# 1993 Corvette: Service Bulletin: Transmission "Whine" Noise, Loss of Motion in all Gears, or Missing Clutch Disc Rivets

**Subject:** TRANSMISSION "WHINE" NOISE, LOSS OF MOTION IN ALL GEARS, OR MISSING CLUTCH DISC RIVETS (REPLACE TRANSMISSION CLUTCH HOUSING)

**Model and Year:** 1993 CHEVROLET CORVETTE WITH SIX-SPEED MANUAL TRANSMISSION AND 5.7L (LT1) ENGINE (VIN CODE P)

**Bulletin Number:** 37-71-40

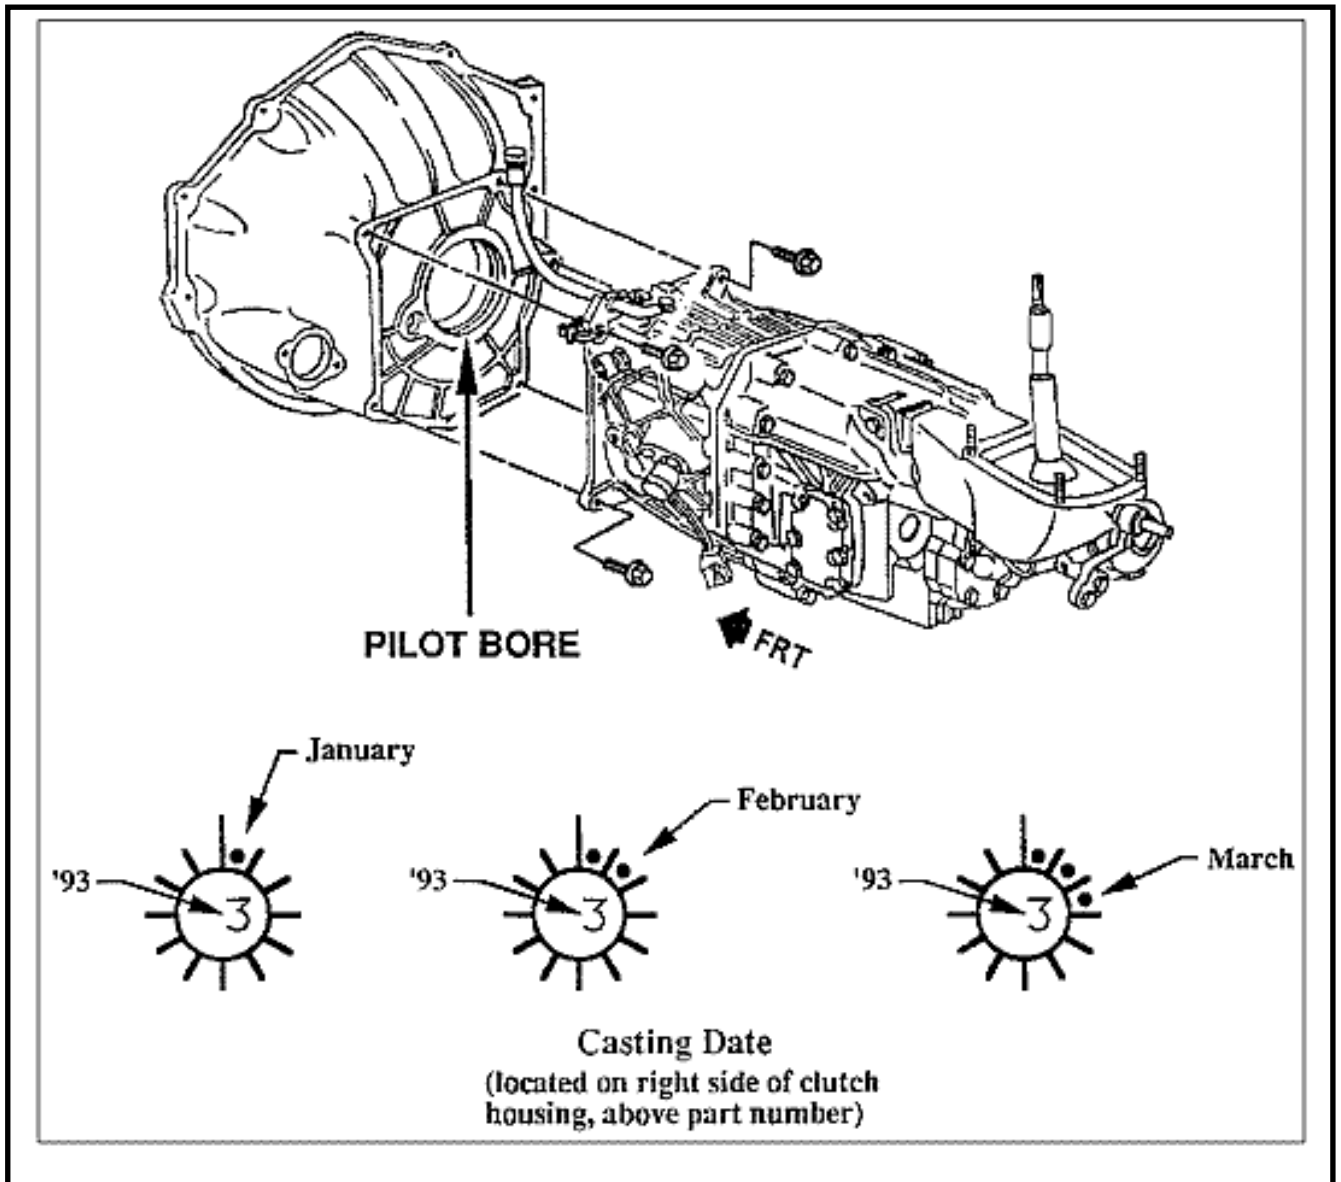
IF THE VEHICLE IS BUILT BETWEEN THE VIN BREAKPOINTS OF 110966 THROUGH 113902 AND THE CLUTCH HOUSING HAS A CASTING DATE OF EITHER "JANUARY, FEBRUARY, OR MARCH 1993", THE CLUTCH HOUSING MAY BE THE CAUSE OF THE CONCERNS. THE CLUTCH HOUSING MAY HAVE A MISLOCATED TRANSMISSION TO CLUTCH HOUSING PILOT BORE. SEE FIGURE.

THIS MISLOCATED PILOT BORE MAY SIDELOAD THE TRANSMISSION'S INPUT SHAFT, THEREBY PRODUCING THE "WHINE" NOISE.

THE ABOVE CONDITION MAY ALSO SHEAR THE RIVETS OF THE CLUTCH DRIVEN DISC CAUSING THE CLUTCH DRIVEN DISC FRICTION FACING TO BE DISENGAGED FROM THE SPLINED HUB.

VERIFY THE SUSPECT CLUTCH HOUSING HAS A CASTING DATE OF EITHER "JANUARY, FEBRUARY, OR MARCH 1993". NOTE: SUSPECT HOUSINGS WILL HAVE NO MORE THAN THREE (3) "DOTS" IN THE CAST DATE. SEE FIGURE.

AFTER ABOVE VERIFICATION, REPLACE CLUTCH HOUSING, P/N 10126448. PARTS ARE CURRENTLY AVAILABLE FROM GMSPO.

NOTE: IF THE VEHICLE REQUIRES A REPLACEMENT OF THE CLUTCH DRIVEN DISC DUE TO SHEARED RIVETS, THE CLUTCH HOUSING \*\* MUST \*\* ALSO BE REPLACED.
